ADDENDUM NO. 03

August 14, 2026

Oak Hill United School Corporation – Multi-School MEP Improvements
405 South Washington St, Swayzee, IN 46986
7760 Delphi Pike, Converse, IN 46919
600 Walnut St, Converse, IN 46919

Addendum Three (AD.03) to the drawings and specifications prepared by Gibraltar Design for **Mechanical Improvements Across Three Schools** for Oak Hill United School Corporation Converse, Indiana.

5
A-410
1 1/2" = 1'-0"

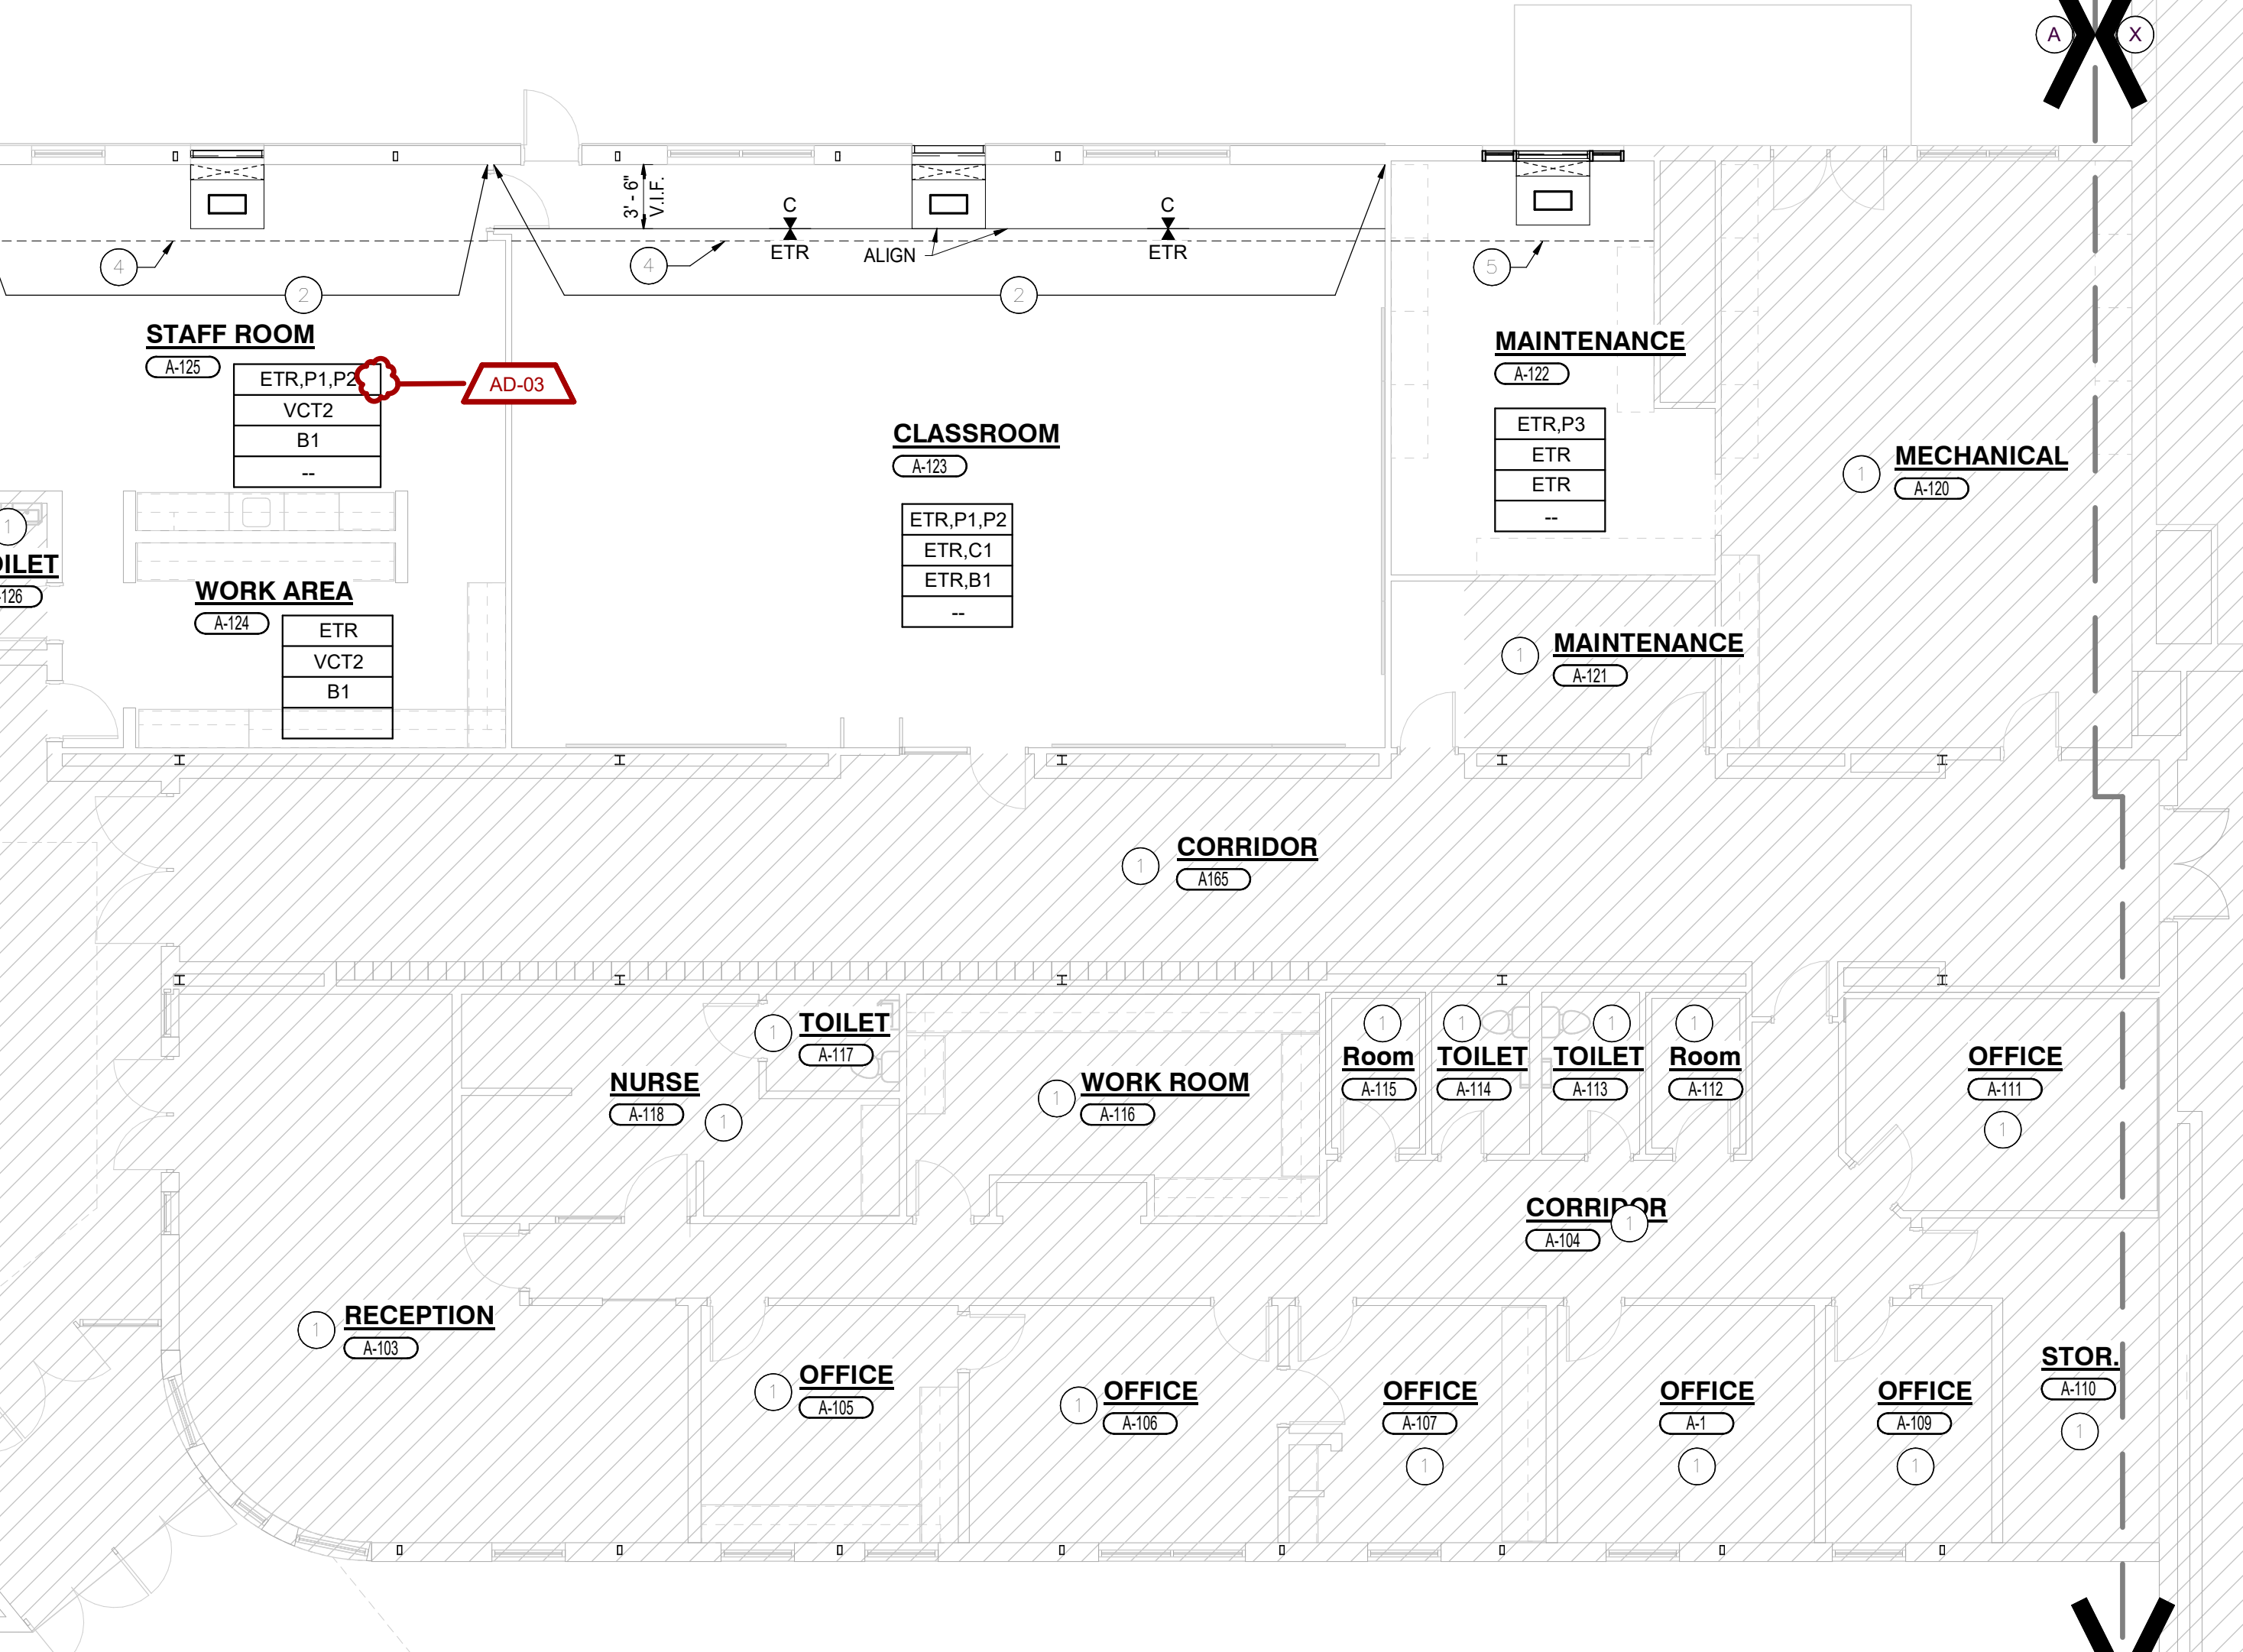
9. Sheet A-410

- A. Refer to revised, full-size drawings, included in this Addendum, for revisions.
